Bridge Park – Dublin, Ohio

P&Z Submittal Summary of Changes

July 31, 2015

1) B1

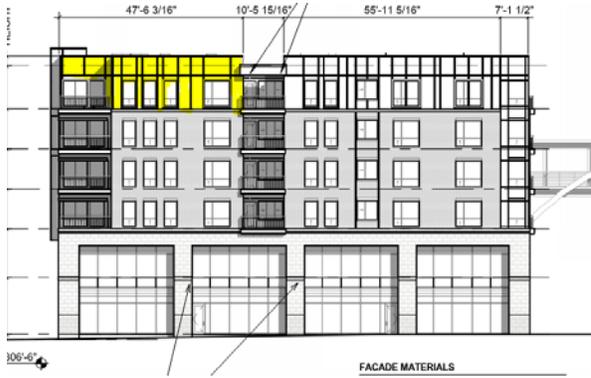
- a) On the west façade the 2 vertical elements that once were 4 levels of fiber cement, have been switched to metal panel.

- b) Thin brick has replaced the cement board at level 6 on the two corner elements on the west side of the Building. The thin brick has been wrapped around to the south and north side of these elements at this level.

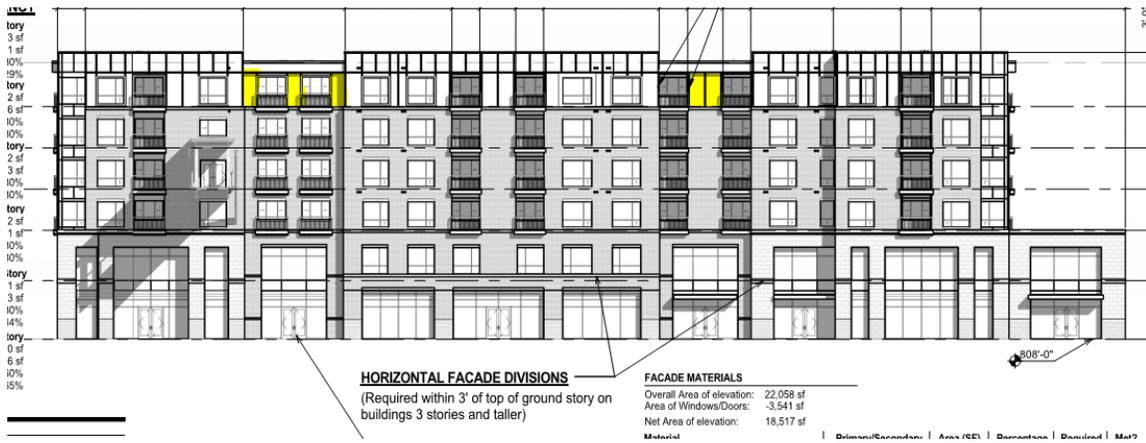
c) On the east side thin brick has been added at level 6 at the entry insets.
